Phase II – Market Reliance

35 A. My testimony addresses the issue of market reliance¹ as it relates to the
36 design and implementation of an Energy Balancing Account Mechanism
37 (ECAM) for Utah. In connection with the issue of market reliance, my
38 testimony discusses:

203 Table 2

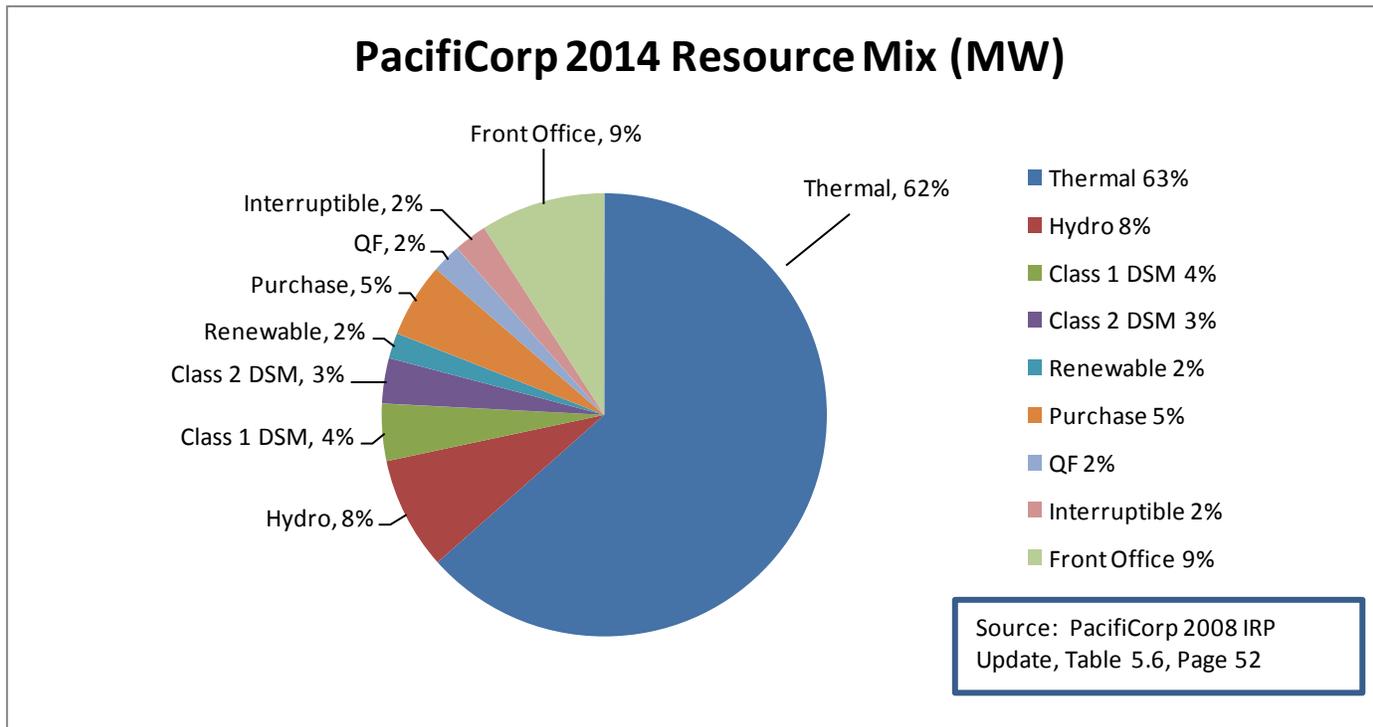
193 A. From a capacity standpoint, short-term resources in the 2008 IRP Update
 194 are approximately 9.0% of the Company’s overall resource mix in 2014.¹⁰
 195 The 9.0% level represents an increase over the 6.8% reported in the 2008
 196 IRP.¹¹ While short-term resources are not a significant component of the
 197 Company’s total resource mix relative to coal or gas combined-cycle
 198 resources, they are proportionately higher in 2014 because of the deferral
 199 of the Lakeside 2 proxy from 2014 to 2015 and changes in assumptions
 200 relating to wind and demand-side management resources. PacifiCorp’s
 201 updated resource mix for 2014 is illustrated in Table 2 below.
 202
